SSDA Mods

1.1 Facade Materiality

Modification 1 to SSDA

Proposed Northern Façade [SMCSWSPS-FOS-OSN-AT-DWG-960004 Rev E]

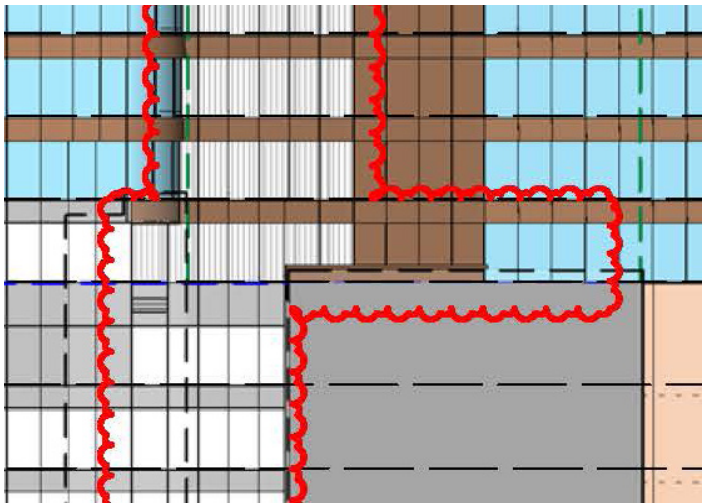
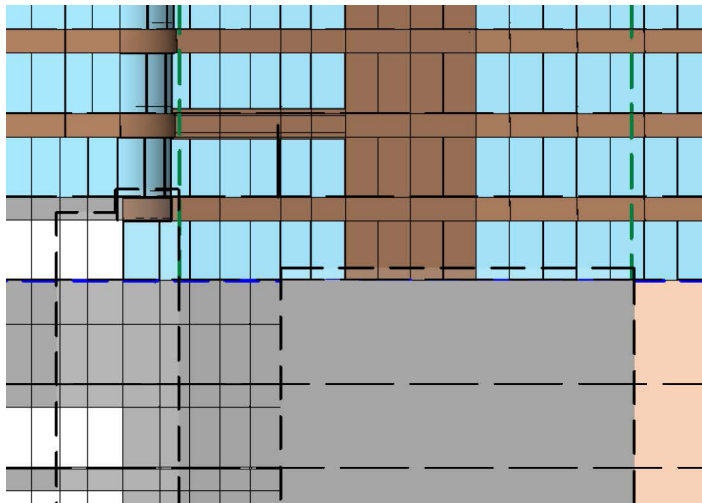
The Level 10 horizontal transom (Facing the Northern Boundary) is adjusted as a development modification to allow for required waterproofing between the proposed development and existing neighbouring buildings.

The proposed modification will not result in any fixture being secured to Ashington Place which protrudes into the PSN site. Sealant will be applied to prevent water seeping in between the PSN OSD and Ashington Place Structures.

Proposed Modification: Modification to L10 Transom

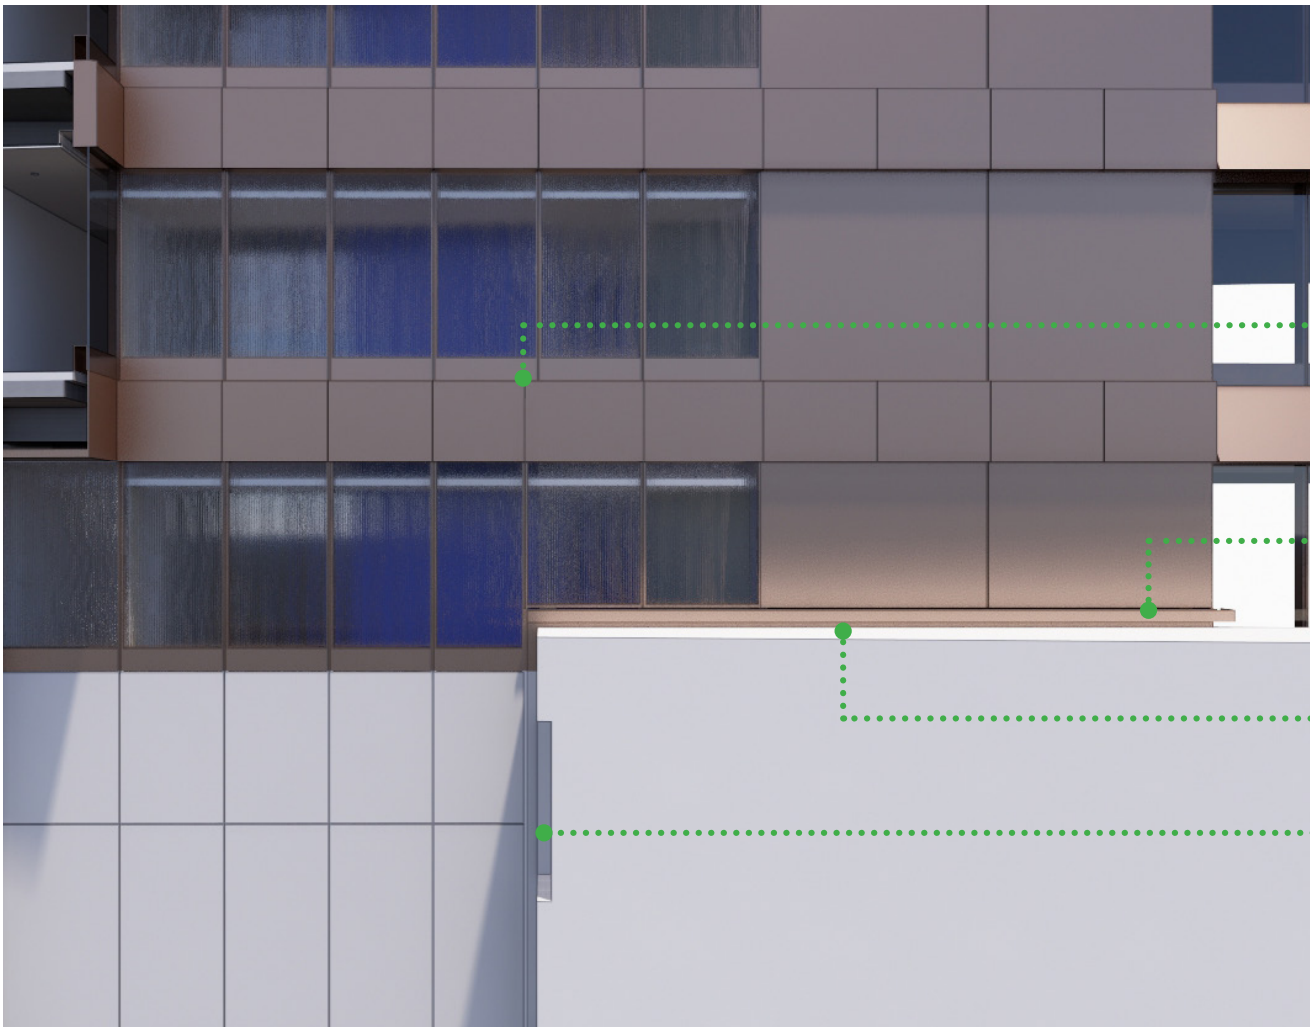
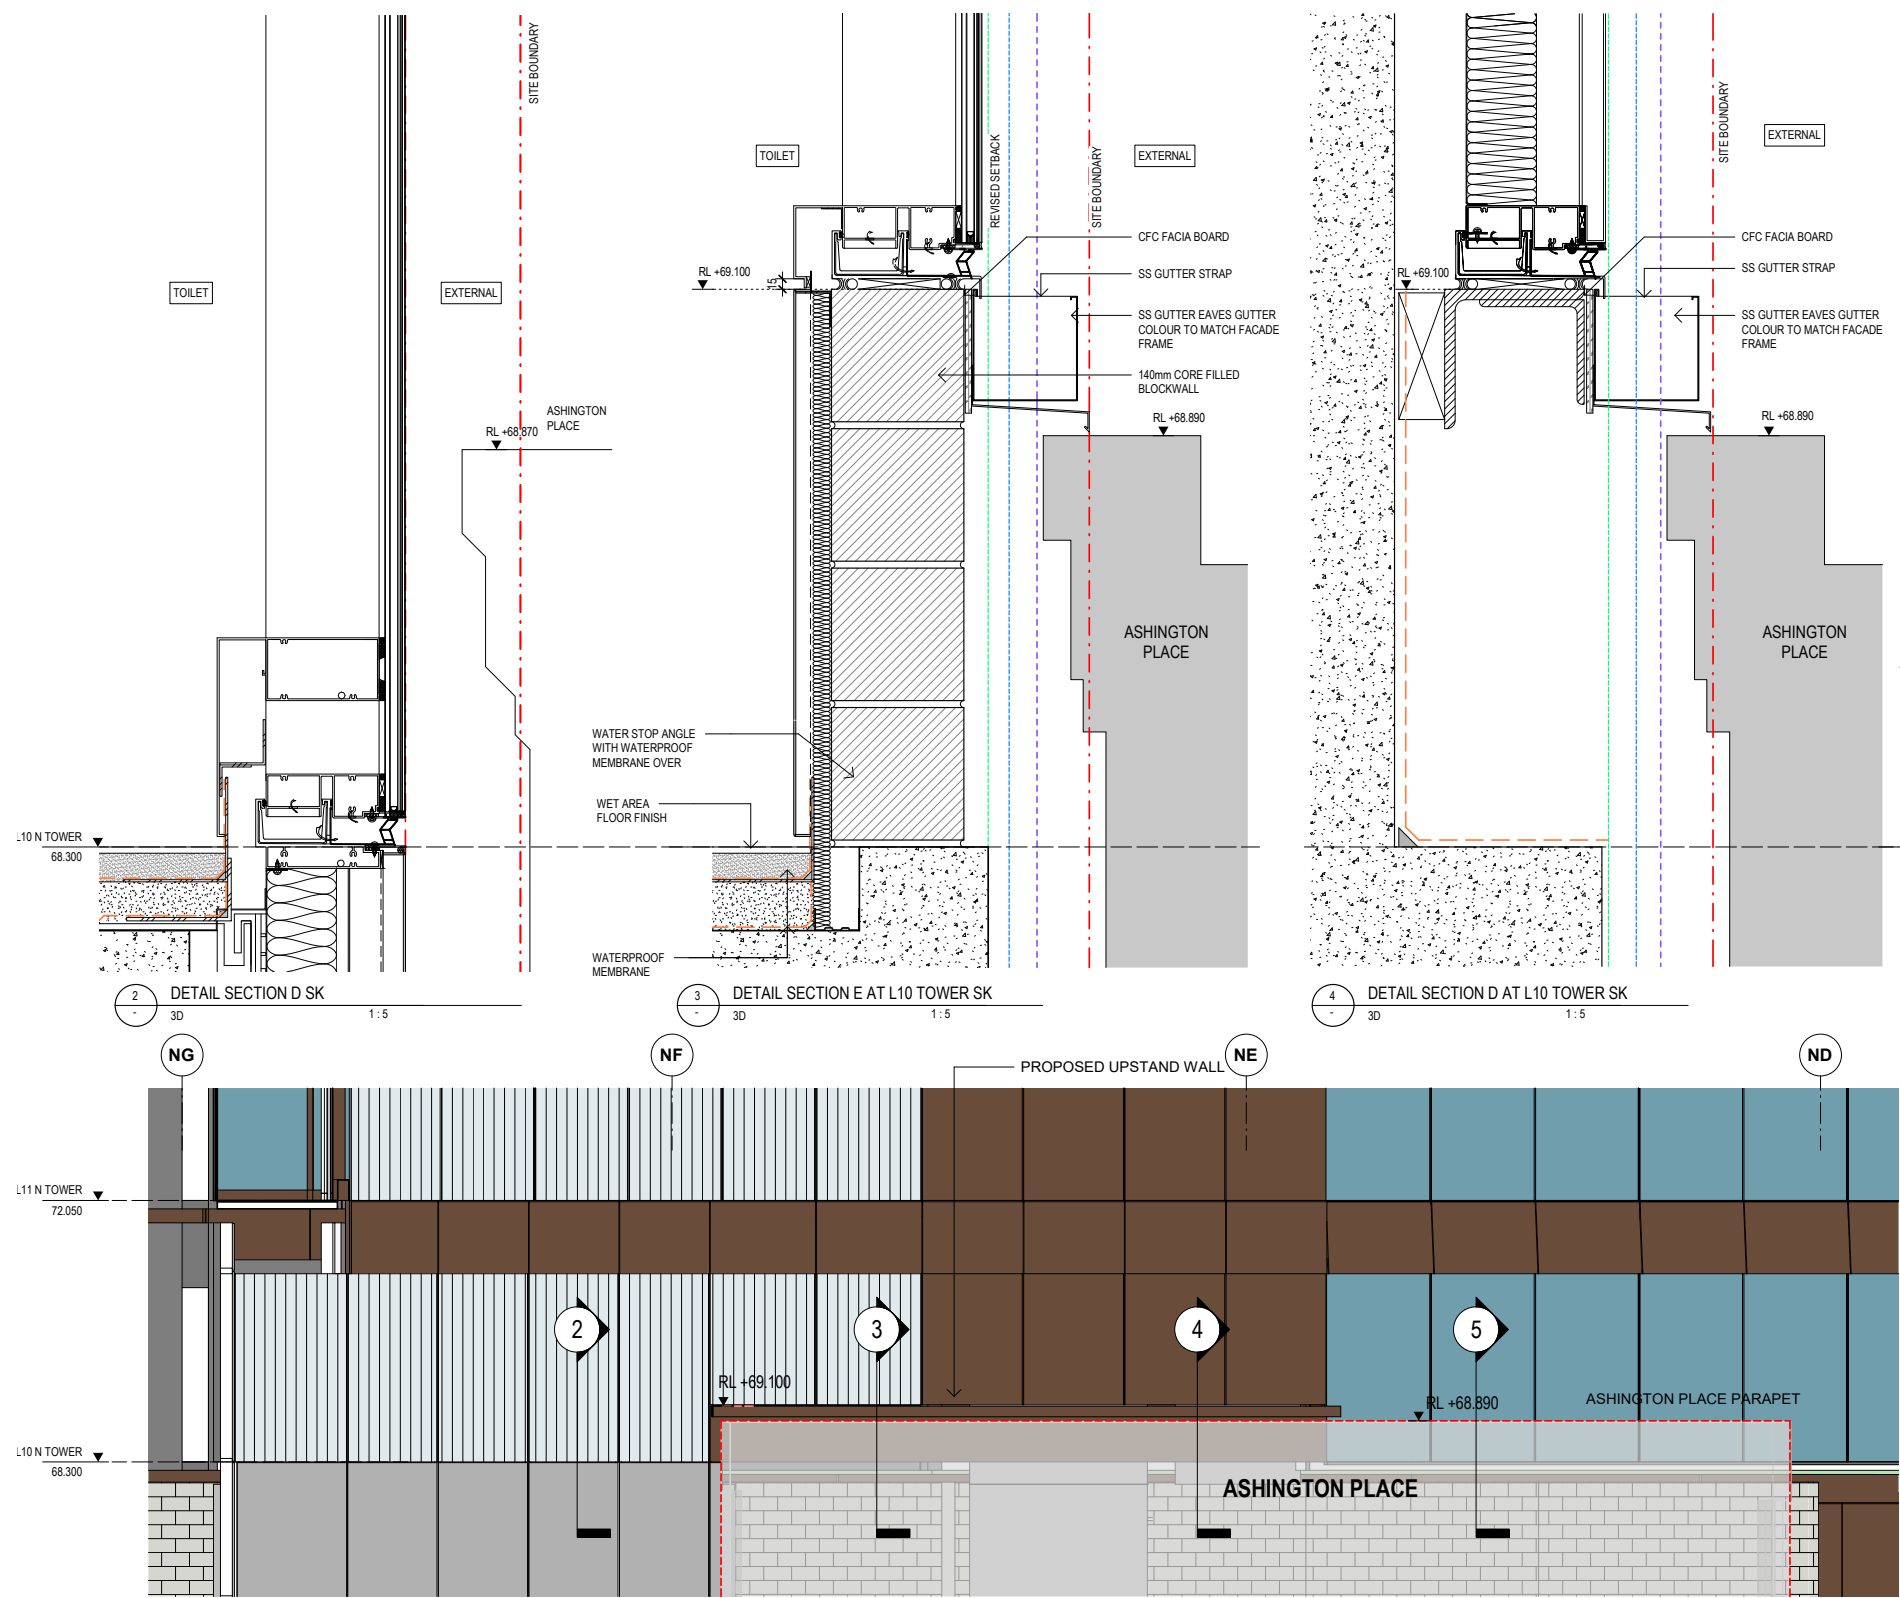
MULLION SHIFTED EAST
APPLIED UPTO LEVEL 5-10.
4x FACADE BAYS EQUALLY
SPACED

GUTTER TO COLLECT
RUNOFF AWAY FROM
ADJOINING NEIGHBOUR

STACK JOINT

VERTICAL FLASHING TO
ASHINGTON PLACE FACADE

The proposed modification will not result in any fixture being secured to Ashington Place which protrudes into the PSN site as per the detailed illustration.

Proposed Modification: South Elevation - Park Street
[SMCSWSPS-COX-OSN-AT-DWG-960002 Rev E]

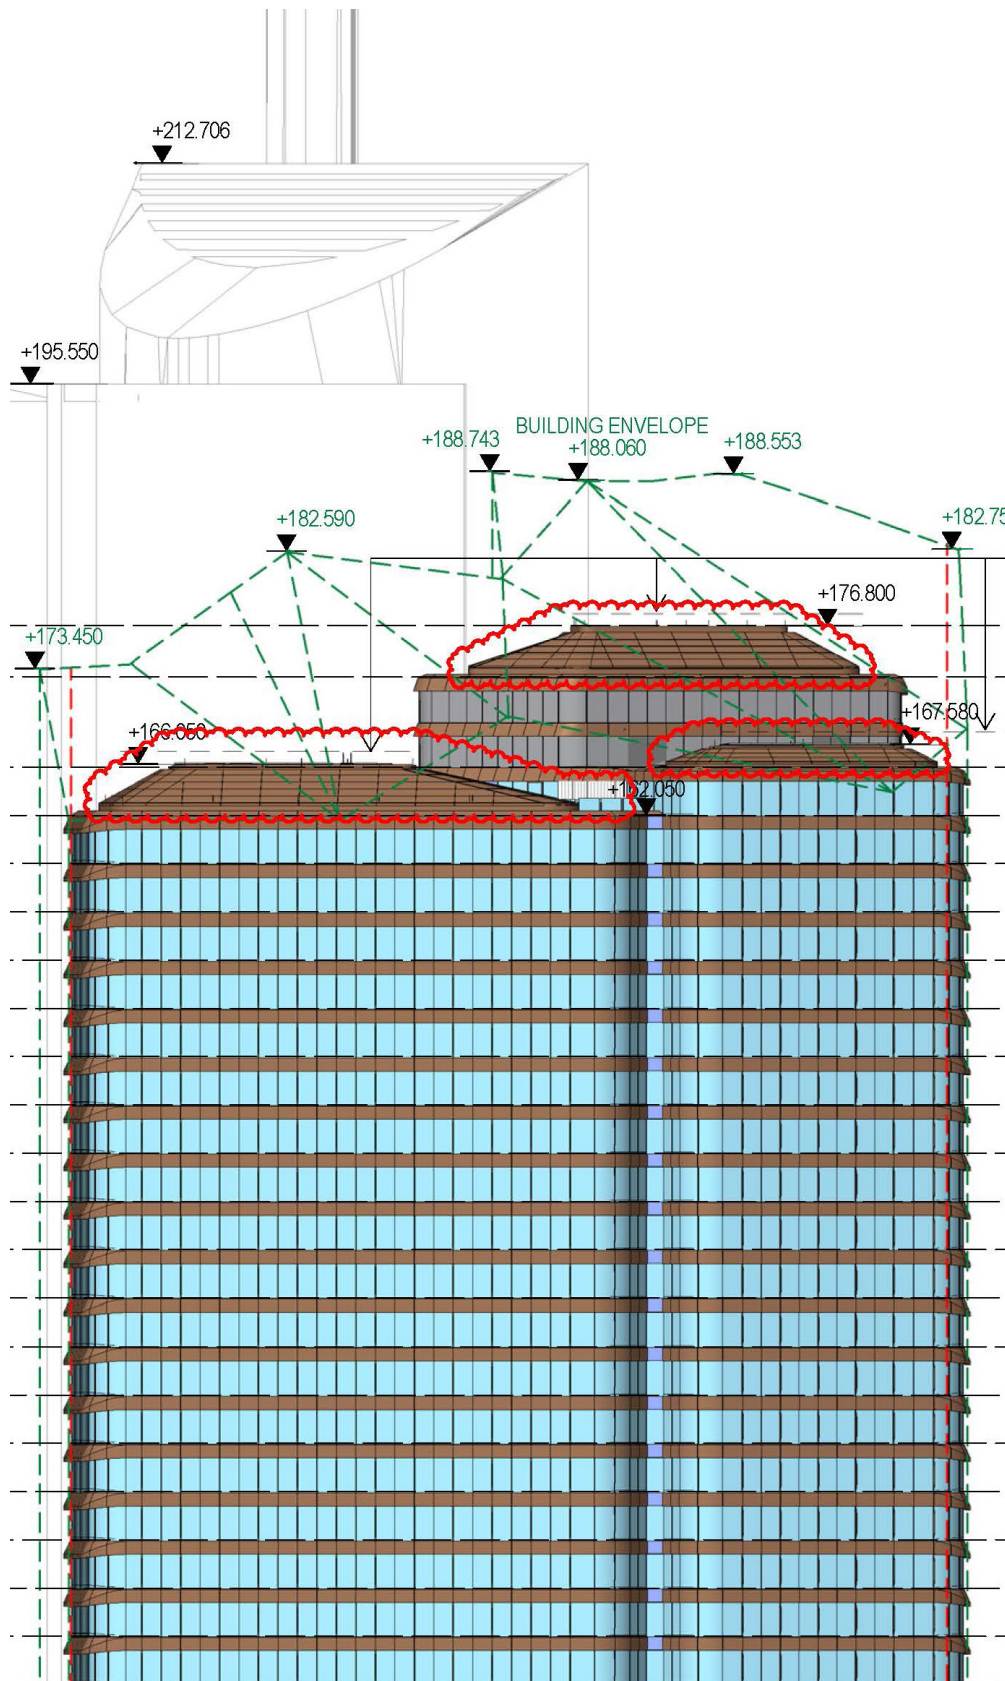
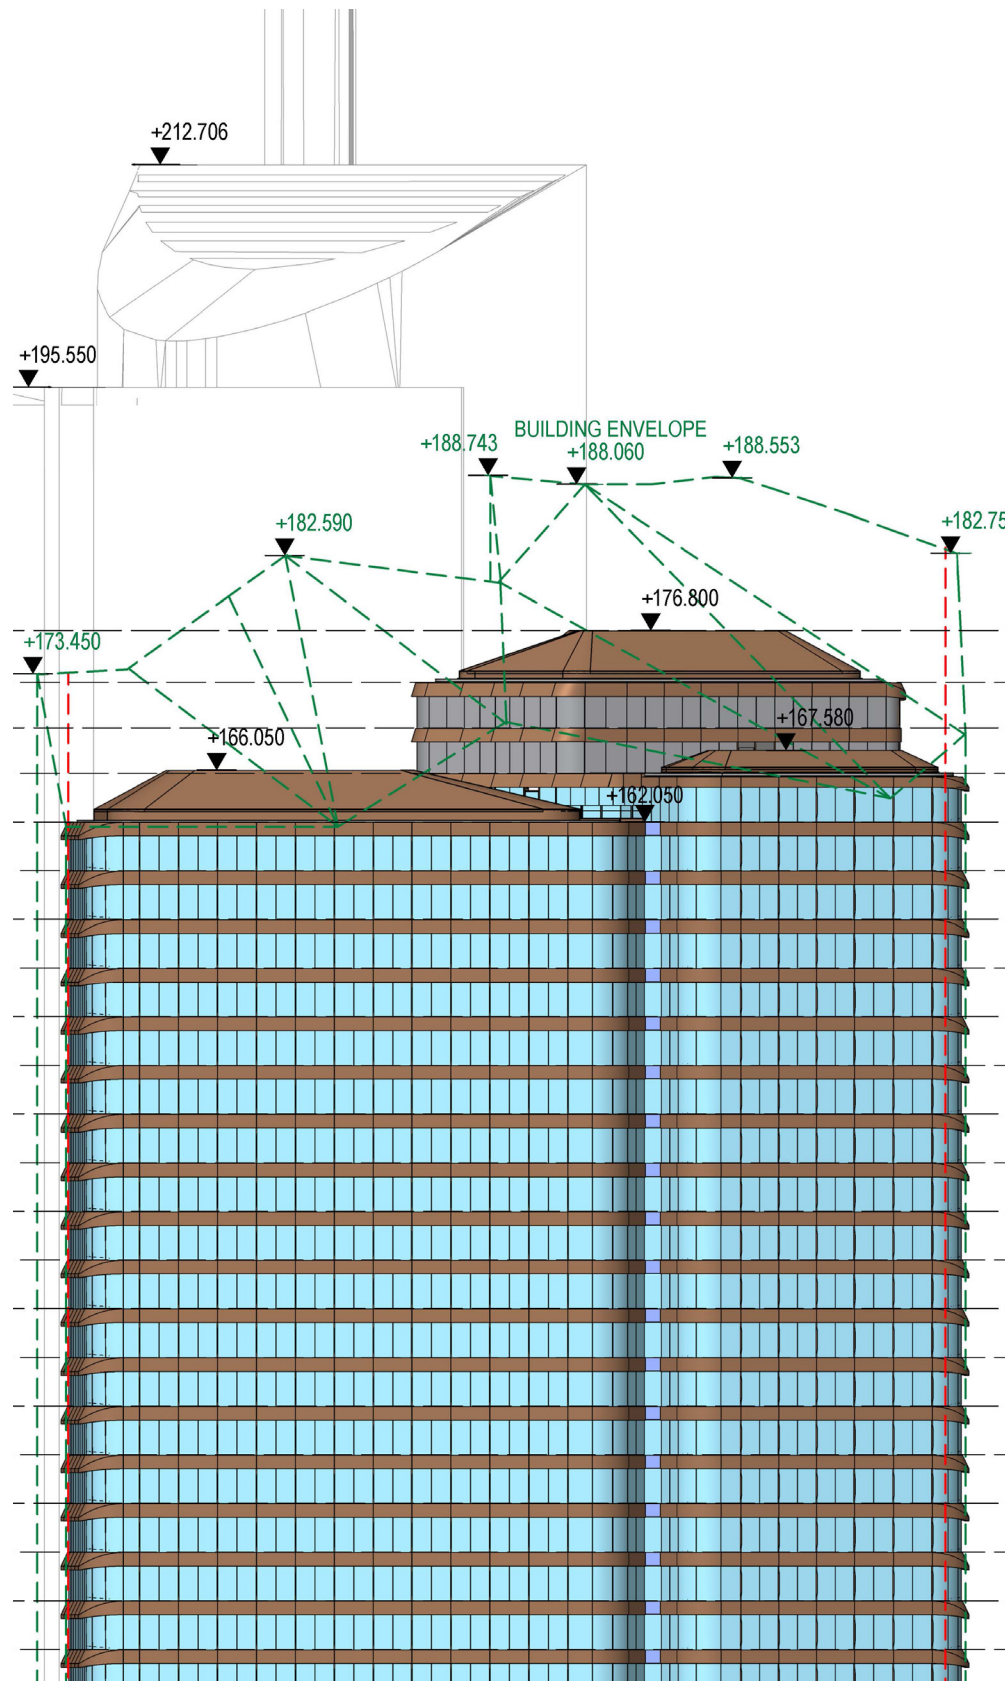
This is a graphical clarification showing the air terminal extent is indicatively located over all roofs.

The height of the air terminals were not previously considered in the buildings maximum height. The air terminals may exceed the buildings maximum height but may not exceed a maximum height of 1m above the respective roof RLs shown.
